MEMPHIS AND SHELBY COUNTY OFFICE OF PLANNING AND DEVELOPMENT #13

STAFF REPORT ADDENDUM

CASE NUMBER: P.D. 07-344 CC L.U.C.B. MEETING: February 14, 2008

DEVELOPMENT NAME: Shelby Park East Planned Development

REVISED SITE PLAN

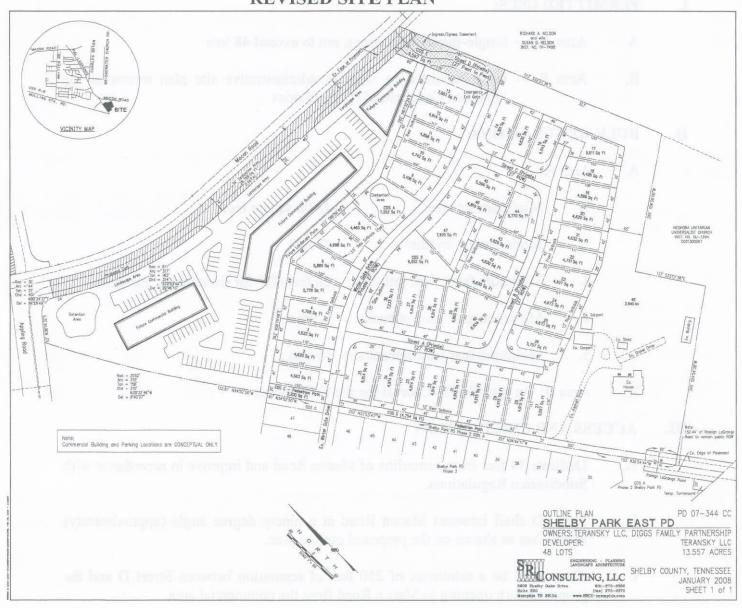
The first issue and of primary important is the proposed use of private drives within this small lot development. The private drives within this development are not desirable because of a couple of important reasons. First, small lots on private drives will not have sidewalks for safe pedestrian access. Public roads which requires the installation of sidewalks are needed to ensure safe and efficient circulation of both pedestrian and vehicle traffic between the residential and commercial areas of this development and the surrounding vicinity. Private drives as proposed in this development are not acceptable to adequately provide this function for its residents.

Secondly, the internal road system should be designed to include a consistent and pleasing streetscape along both sides of the road that will add to the overall appearance of this development's public realm. This is especially true given the lack of open green space along the frontages of small lot developments with a narrow road system. Twenty-seven (27) foot wide street widths are proposed throughout this development with a 20 foot front yard setbacks on each lot and no sidewalks. This type of design will not encourage or promote this development as a walkable neighborhood.

One last and important point concerning the design and layout of this site plan. The site plan shows that the closest access to Macon Road is via an emergency exit only gate along the eastern side of the development. Macon Road is where the commercial/retail uses will be located within this development. Residents that wish to make a short trip to this area are expected to walk along private roads with no sidewalks to a pedestrian path that is provided at only one point in this development, along the western site boundary. Those that can't walk or do not wish to walk for whatever reason will be required to drive approximately 435 feet eastwardly to access the intersection of Appling and Macon Roads. Once at this intersection the residents will have to backtrack eastwardly to access the commercial center that will be adjacent to the north side of this residential community. A more convenient vehicle route and a second pedestrian path should be provided within this development to allow easier access to this commercial area.

A last item of concern pertains to the lack of a proposed detention stormwater areas in Area B that is separate from Area A as recommended by County Engineering. There is still no information or details concerning a proposed detention area in Area B on the site plan for consideration and early review by the appropriate governmental department. The County Engineering Office indicates that the placement of separate detention areas in both the residential and commercial portions of this development is very important and should be shown on the site plan. Staff agrees with the County Engineering that this information is needed on this conceptual site plan.

There is one additional item that should be pointed out for correction by the applicant. The site plan shows the proposed southern property lines to be closer than 5 feet to the existing carports that are located on proposed Lot 48. The Section 27. D.1.a. of the Zoning Ordinance requires that detached accessory structures (carports) be located not less than 5 feet from any side or rear lot line. The site plan should be revised to show this required setback for the existing accessory structures on Lot 48.

There are two options recommended to the resolve this issue. First, the applicant could change the private drives to public streets that would be dedicated and improved to public standards which include the provisions of sidewalks and planting green streetscapes. Secondly, the applicant could keep the private drives and build them to public standards which would include sidewalks and a tree lined green strip along both sides of the roads throughout this development. This option would provide for a 48 foot wide ROW that would include 28 feet of pavement from back of curb to back of curb, a 4 foot wide sidewalk, and a 6 foot wide tree green, exclusive of the 20 foot front yard setback on each lot (27 foot front yard setback for front facing garages). Either of these two options would aid in creating a desirable outdoor space for the residents of this new community.
